Access Compliance Report

Public Rights-of-Way

(Curb Ramps)

Intersection ID: 10015389	Main Street: CALDWELL_FOREST_DR	Cross Street: N/A	Location: E
ADA ID: E675355845C9	Ramp Type: PerpDiag	Initial Pass/Fail: Fail	Overall Compliance: No
			Severity Score: 13.75

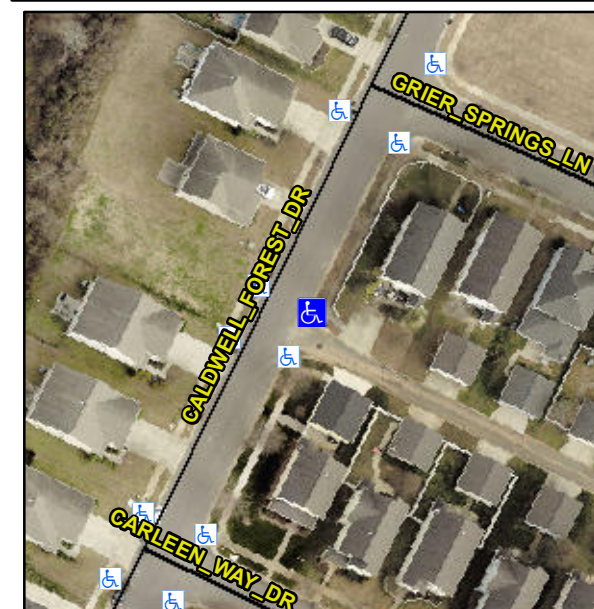
Not Found, R304.2.2, R304.5.3

Compliance	Description	Data	Compliance	Description	Data
N/A	Ramp Length (in)	46.5	No	Ramp Slope (%)	11.1
Yes	Ramp Width (in)	50.0	No	Ramp XSlope (%)	2.9
N/A	Flare Type LT	N/A	N/A	Flare Type RT	N/A
N/A	Flare Slope LT (%)	N/A	N/A	Flare Slope RT (%)	N/A
N/A	Flare Traversable LT?	N/A	N/A	Flare Traversable RT?	N/A
N/A	Landing Length (in)	N/A	N/A	DWS Provided?	N/A
N/A	Landing Width (in)	N/A	N/A	DWS Contrast?	N/A
N/A	Landing Slope (%)	N/A	N/A	DWS Length (in)	N/A
N/A	Landing X Slope (%)	N/A	N/A	DWS Full Width?	N/A
N/A	Landing Curb? (Y/N)	N/A	N/A	DWS Offset (in)	N/A
N/A	Shared Landing?	N/A			
N/A	Gutter Ponding?	N/A	N/A	Gutter Slope (%)	N/A
N/A	Gutter Lip Ht (in)	N/A	N/A	Gutter X Slope (%)	N/A
N/A	Painted X Walk1?	No	N/A	Painted X Walk2?	No
	X Walk 1 Direction	To W		X Walk 2 Direction	To S
N/A	X Walk 1 Width (in)	N/A	N/A	X Walk 2 Width (in)	N/A
	X Walk 1 Slope (%)	1.4		X Walk 2 Slope (%)	0.7
	X Walk 1 X Slope (%)	2.4		X Walk 2 X Slope (%)	1.3

Remove & Replace Curb Ramp With Two New Directional Ramps or Equivalent.
